# Addendum No. 4 Berkeley Springs Bath House DNR 209090

# DEPT. of Natural Resources Additions and Alterations to Berkeley Springs Bath House

#### AAI PROJECT NO.: 0408097.02 DNR-209090 February 12, 2009

rev. by: RJK	DWG. DESCRIPTION: CORRECTION TO FRAME	DWG. NO: AD-001
DWG, BY: RTL	TYPE F-4	PBI NO:
DATE: 2-12-2009		SHEET REF: A-6.2
	RATIONS & UPGRADES TO THE (ELEY SPRINGS BATH HOUSE	PROJECT NO: 0408097.02

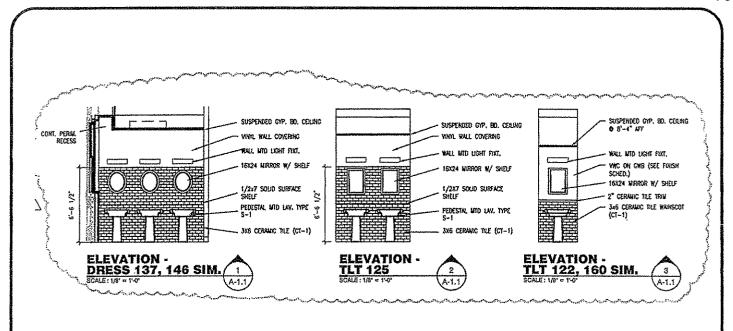
3.01 Sheet A-6.2; Frame Detail Type F-4
ADD: See AD-001 attached. Type F-4 has 4 transom lites.

4.04 Q: Dwg. A6.2, F-4 shows a transom with two lites. Dwg. A3.1 and A4.6 shows a transom detail with four lites. Please clarify.

A: Drawing of Door D101 as shown on A-3.1 and A-4.6 is correct. Please see AD-001 attached. See 3.01 above.
